# **Attachment A**

## **WMK Response to Recommended Condition of Consent – 12-20 Rosebery Avenue**

### ***(6) DESIGN MODIFICATIONS***

## DESIGN ADVISORY PANEL DRAFT COMMENTS I - ADDITIONAL SOLAR SHADING

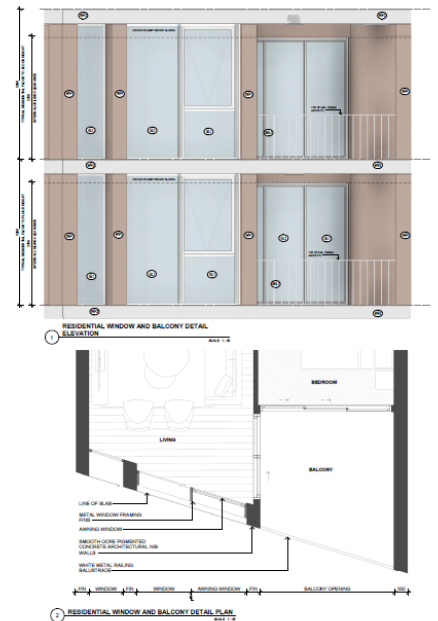
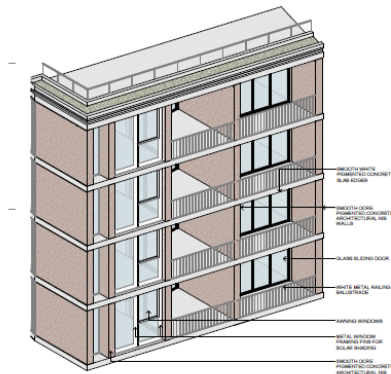
*Further solar shading needs to be provided to the western apartments at level 5 and to the northern apartments at lower levels.*

The facade treatment has been further developed to address the individual requirements of each cardinal elevation. Depth and setback glazing have been adopted where solar gain is prominent and solar shading is preferable. Northern and western facades have been intergrated and additional shade screens have been applied where applicable.

All apartments comply with BASIX

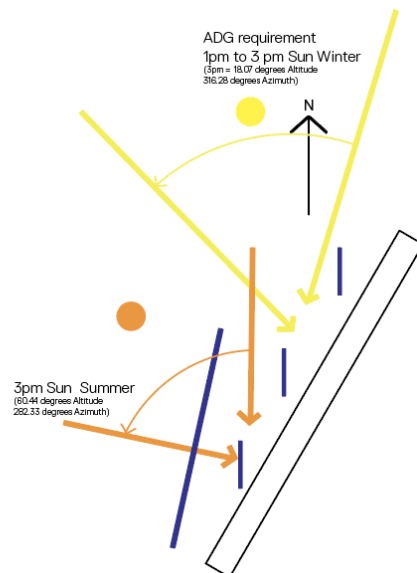
*(c) The plans are to be amended to provide a target of 50% external solar shading (by area) to address summer solar heat gain through:*

*(i) external solar shading to the exposed glazing of the northern elevations of levels 1, 2 & 3 of both the Rosebery and Dalmeny Avenue buildings (50% effective at 12 midday in summer).*

*(ii) external solar shading to the exposed glazing of the western elevation of the Rosebery Avenue and Dalmeny Avenue buildings (50% effective at 3pm in summer). External shading is permitted to intrude in the 3m setback line from Rosebery Avenue for the upper levels. Ground levels to both buildings is excluded from this requirement.*

#### **1. Impact on Facade Design and Design Excellence Outcomes – (See diagrams below)**

The proposed development has undergone a rigorous Design Excellence process, including independent review and refinement of facade articulation and materiality. The introduction of additional fixed louvre systems across north and west-facing facades would fundamentally alter the carefully balanced design outcome, obscuring the architectural language that was a cornerstone of the endorsed scheme. These changes are not minor technical adjustments but significant modifications to the built form, facade rhythm, and overall presentation of the project.

## SOLAR DIAGRAM – CURRENT VS REVISED DESIGN - SUMMER

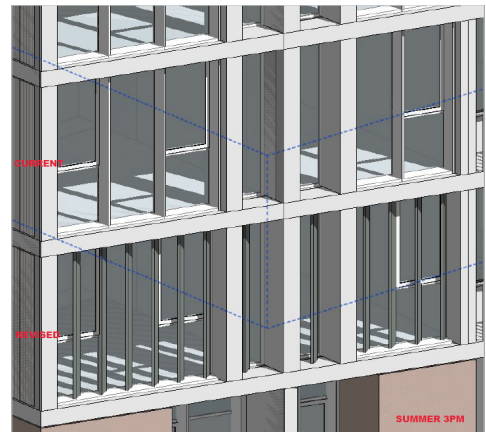
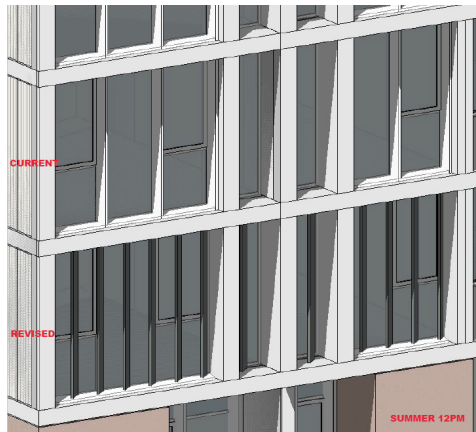
The request for 50% effective shading at 3 pm in summer on western facades directly conflicts with the Apartment Design Guide (ADG) solar access requirements, which require sunlight to penetrate living rooms between 1 pm and 3 pm in winter.

- A fixed external louvre system capable of achieving 50% shading at 3 pm in summer will also block a significant proportion of low-angle winter sun at the same orientation.
- This results in a loss of winter solar amenity, undermining the ADG objective of providing natural light and thermal comfort in the cooler months.

The design already incorporates a suite of passive design strategies to manage solar gain, including:

- High-performance glazing systems to mitigate heat load without heavy external devices.
- Balcony projections and slab noses that provide effective horizontal shading on north-facing apartments at midday.
- Carefully considered building orientation and separation, ensuring good cross-ventilation and minimising reliance on mechanical cooling.

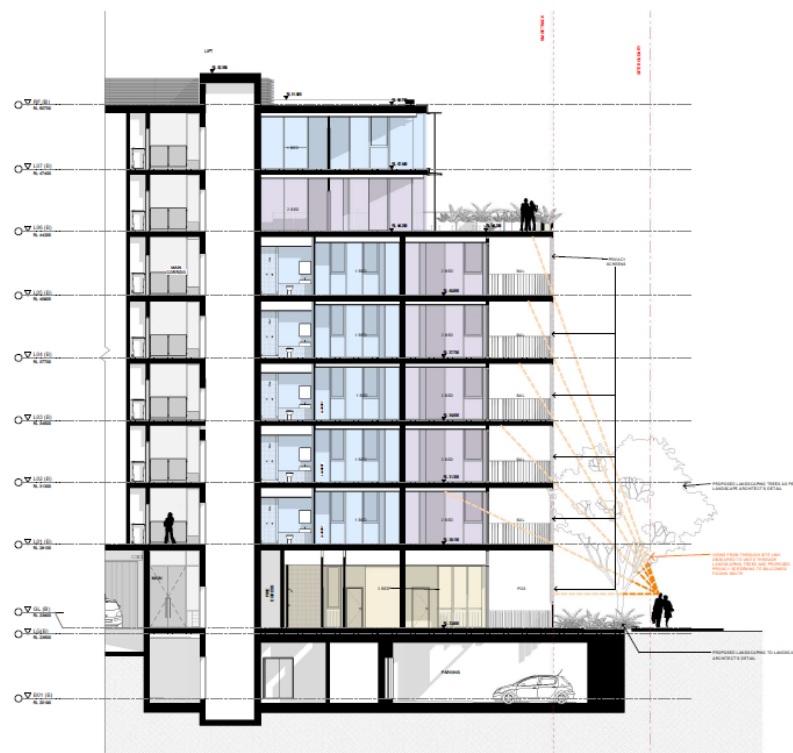
*6 (d) Additional privacy elements are to be incorporated into the private balcony balustrades to provide adequate privacy to private open space from the public domain. This could be addressed via colour matched solid metal upstands being added behind the metal palisade balcony treatments up to a height of 760mm*

WMK consider that privacy from the public domain has been adequately addressed and request the condition is removed.

The requested introduction of 760mm high solid balcony panels is considered to be a significant departure from the competition approved façade design that impacts negatively upon the apartment's outlook and amenity.

Privacy from the public domain has been carefully considered in the design.

Balcony depths to upper-level apartments have been configured to provide privacy when viewed from the street. Landscape fencing, screens and planting have been configured to provide privacy to ground floor apartments.

The below diagram depicts a privacy view from the street showing direct views into the apartments from the public domain does not occur.
